SUBJECT: Transmittal Memorandum for EHB-9 Issuance 02-07

Engineering Handbook No. 9 (EHB-9), Automatic Radiotheodolite (ART-1/2), Section 2.3, Maintenance Note 28, Amplifier Switches P/N SA-23025-0103 or GHG 122 3121D 1003 and Safety Barrier Switch P/N SB0728 with SB9102 Mounting Bracket Installation, Revised Hydrogen Safety Switch Control Box Schematic Drawings

MAINTENANCE NOTE 28 (for Electronics Technicians) Maintenance, Logistics, and Acquisition Division

PURPOSE : To provide revised amplifier switch and safety barrier switch

Figure 1

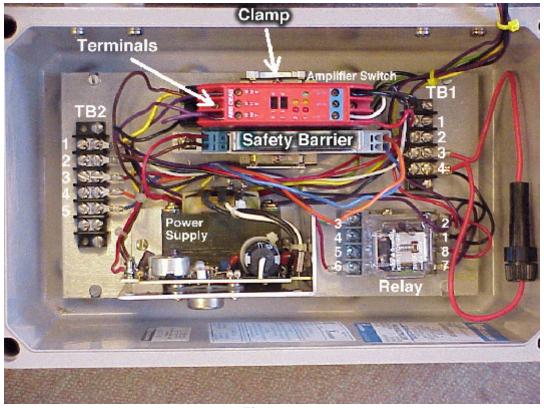
- 1. At the balloon inflation building, locate the main power breaker and turn off the alternating current (AC) power to the inflation building.
- Open the lid of the hydrogen safety switch by loosening the two (2) plastic fasteners, (figure 1).
- 3. With a VOM, verify no AC power exists at TB1 terminals 1 and 2 inside the hydrogen safety switch.
- 4. Remove the leads from the terminals of the amplifier switch (figure 2).
- 5. Loosen the clamp on the left rail mount (figure 2) and remove.
